**RAI 03.07.01-27, Supplement 1, Revision 1**

**Follow-up Question to RAI 03.07.01-19 (STP-NRC-100093)**

**REVISED SUPPLEMENTAL RESPONSE:**

**RAI 03.07.01-27, Supplement 2, Revision 1**

**Figure 03.07.01-27.7 - 5% Damped Spectral Comparison in X Direction at Top of Roof Slab (Center), El. 50.0 ft**

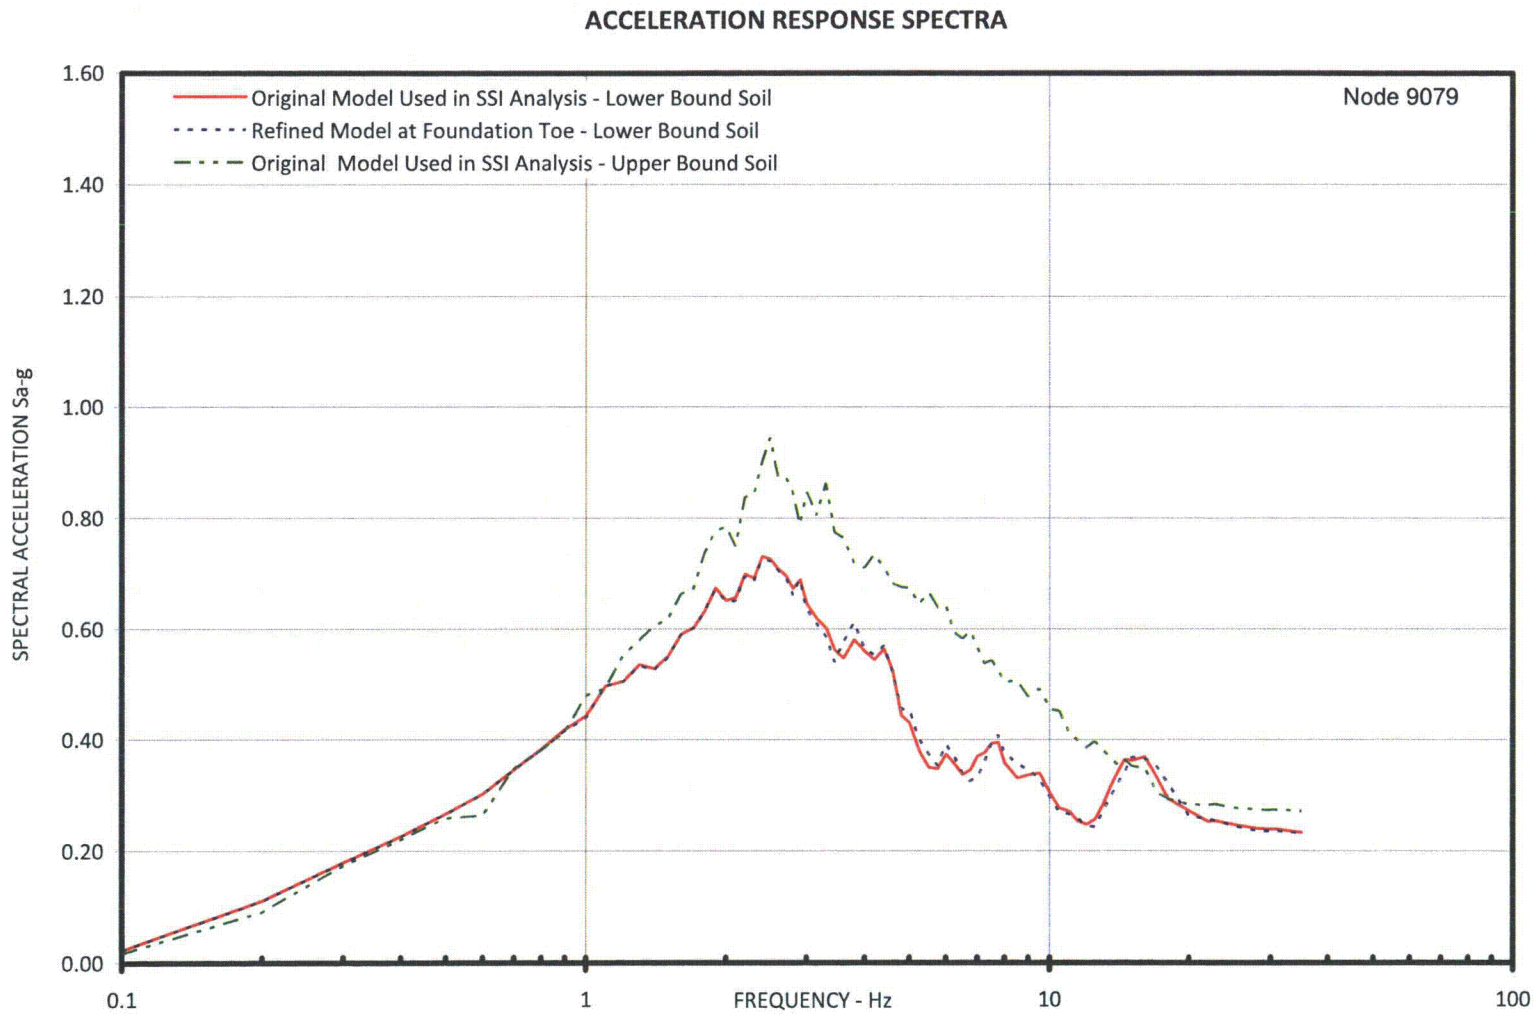
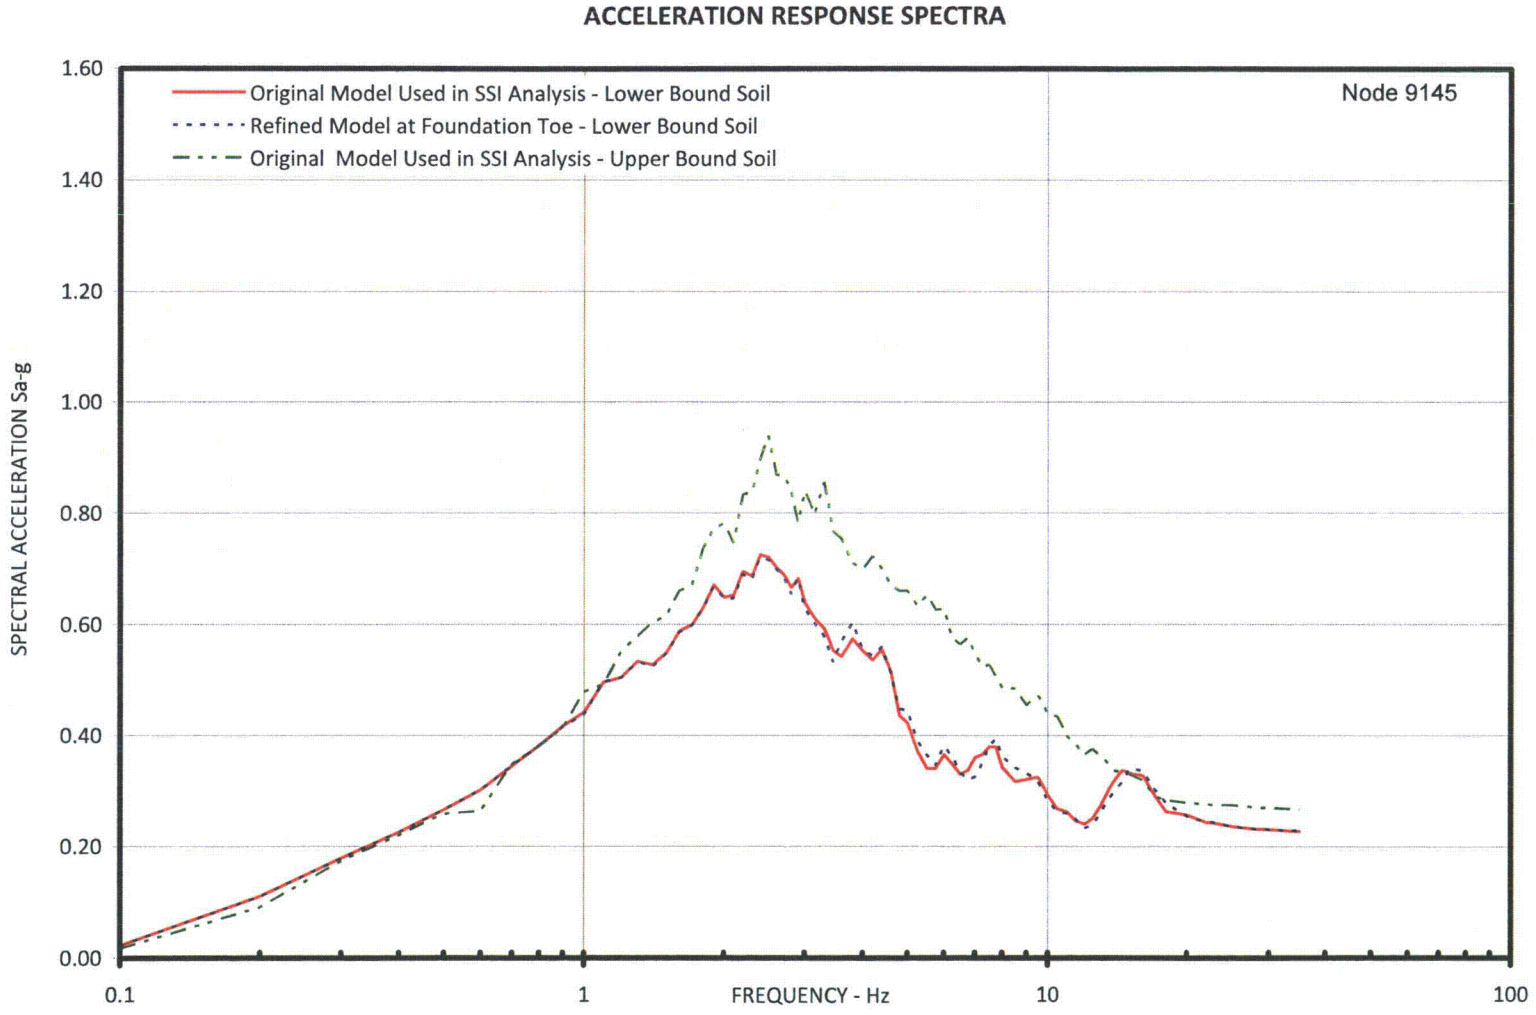
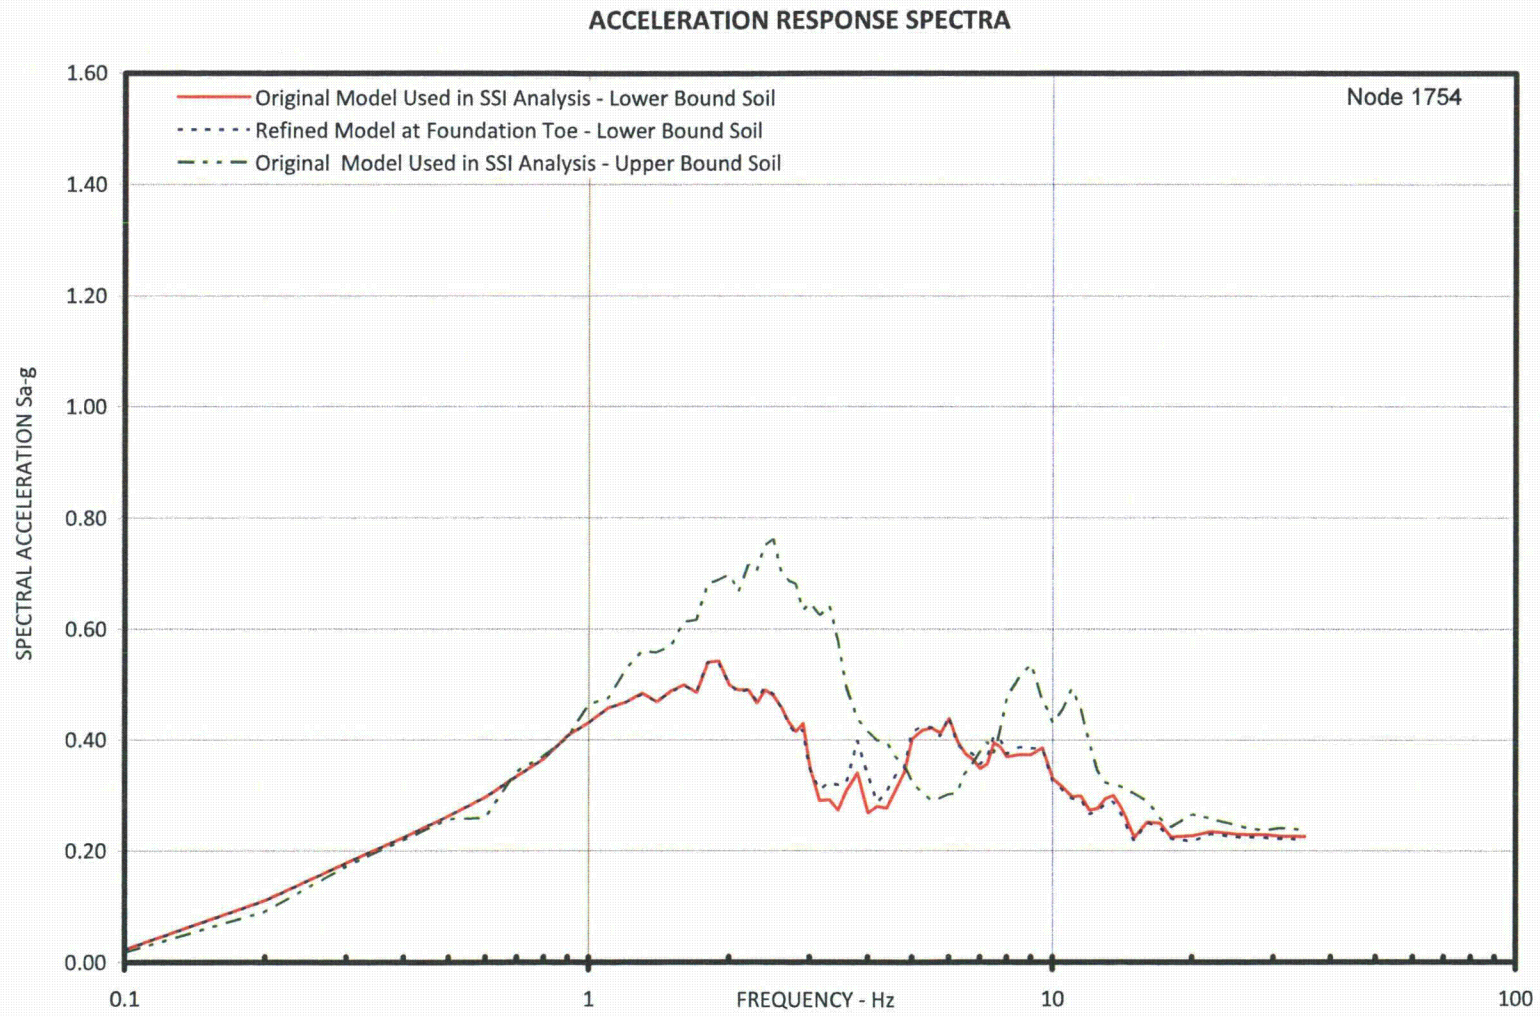
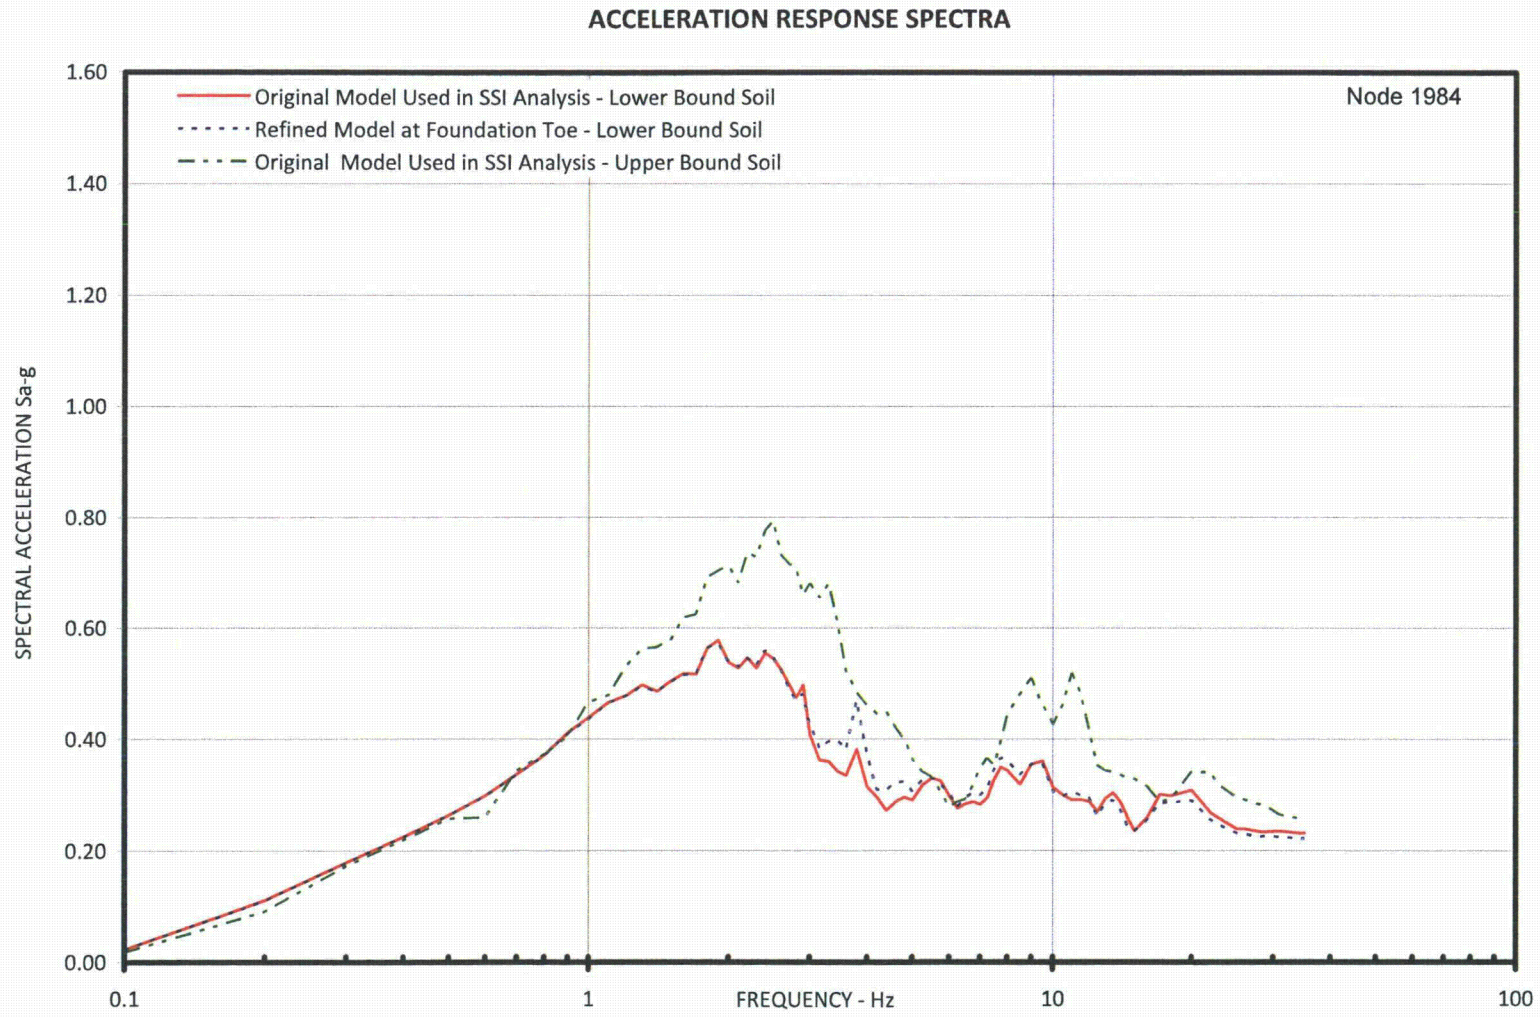
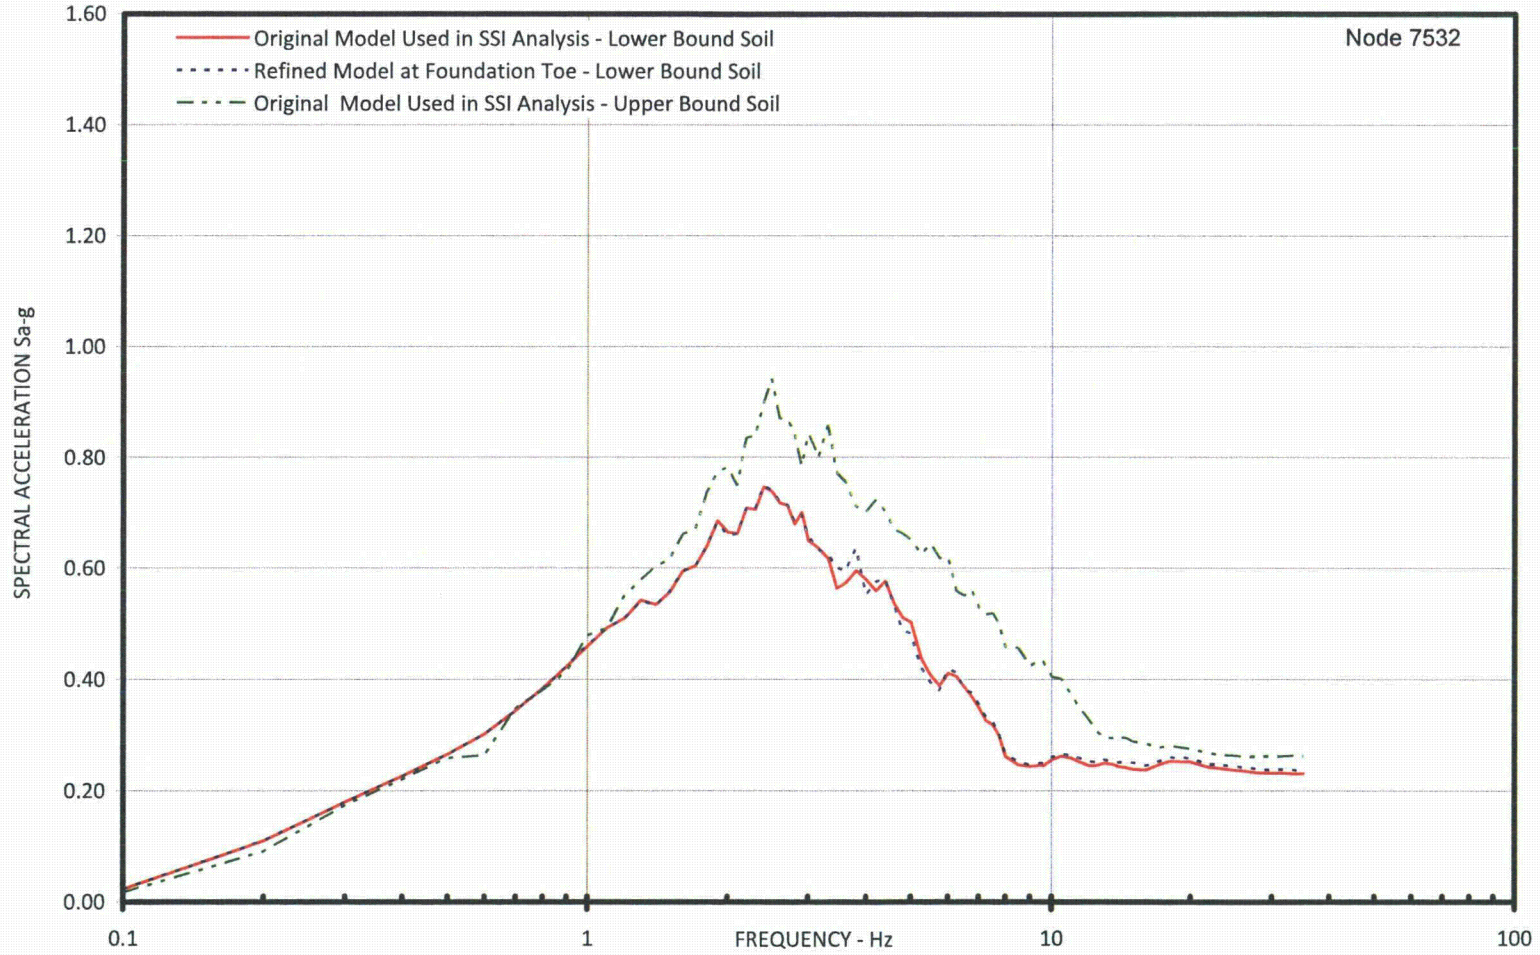
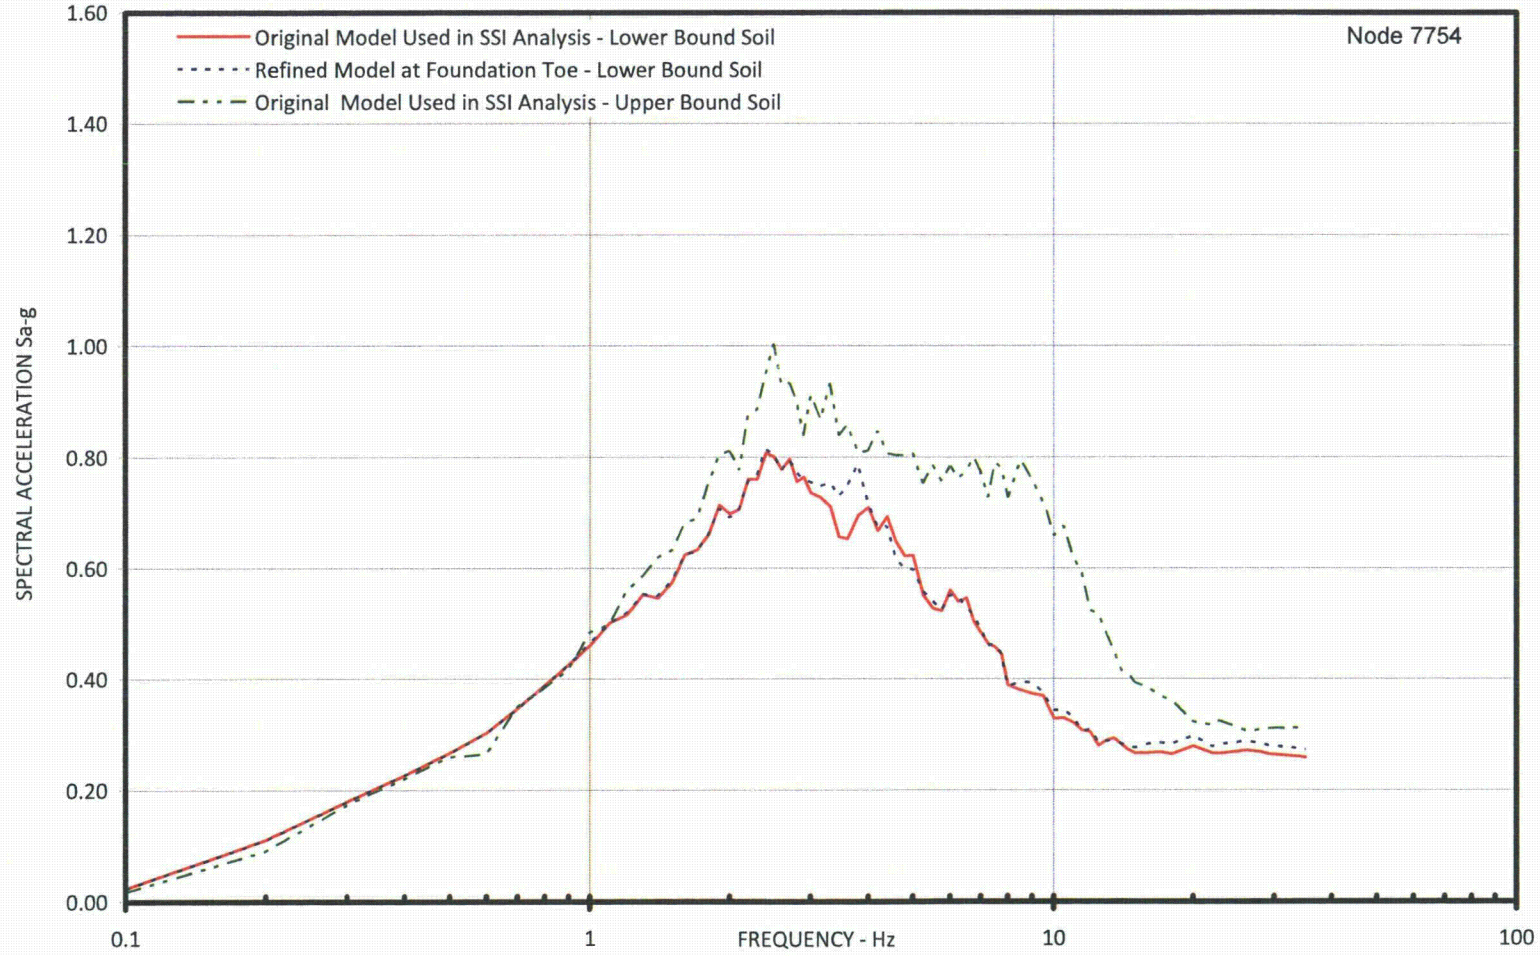
1. 10CFR50, Appendix S requires that evaluation for SSE must take into account soil-structure interaction (SSI) effects and the expected duration of vibratory motion. In the response to the first paragraph of RAI 03.07.01-19, the applicant has presented its approach for developing the input motion for the SSI analysis and design of the DGFOSV that takes into account the impact of the nearby heavy RB and RSW Pump House structures. The applicant also stated that *"Conservatively, a 3-dimensional SAP2000 response spectrum analysis was used to obtain the safe-shutdown earthquake (SSE) design forces due to structure inertia. The seismic induced dynamic soil pressure on DGFOSV walls were computed using the method of ASCE 4-98, Subsection 3.5.3.2"* The response, however, does not provide details as to how the SSI analysis of the DGFOSV are performed and how the input motion developed are subsequently specified in the SSI analysis of DGFOSV to develop the structural response and in-structure response spectra for any equipment and subsystems within DGFOSV. From the response it appears that the applicant has not included explicitly DGFOSV structural model in the SASSI model of the RB and RSW Pump House structures to properly evaluate the SSSI effect on the DGFOSV. In order for the staff to determine if the evaluation of DGFOSV for SSE has appropriately accounted SSI effects, the applicant is requested to provide in the FSAR the following information:

To evaluate the effect of 20 Hz passing frequency for LB in-situ case, the foundation toe was divided into two elements, thus increasing the passing frequency to 40 Hz. This refined model with LB in-situ soil properties was analyzed and 5% damped spectra from this model were compared with the spectra from the original model with passing frequency of 20 Hz. The spectra comparison plots are shown in Figures 03.07.01-27.1 through 03.07.01-27.24. The comparison shows that:

- In the X direction, there is insignificant difference between the response spectra from the two models
- In the Y direction, the response spectra from the two models matched well except at frequency of about 3.8 Hz where the refined model produced higher spectra.

However, spectra from both the models are enveloped by the spectra for UB in-situ soil case

- In the vertical direction, the spectra from the two models matched well (insignificant difference)

Based on the above evaluation it is concluded that the horizontal direction passing frequencies are acceptable.
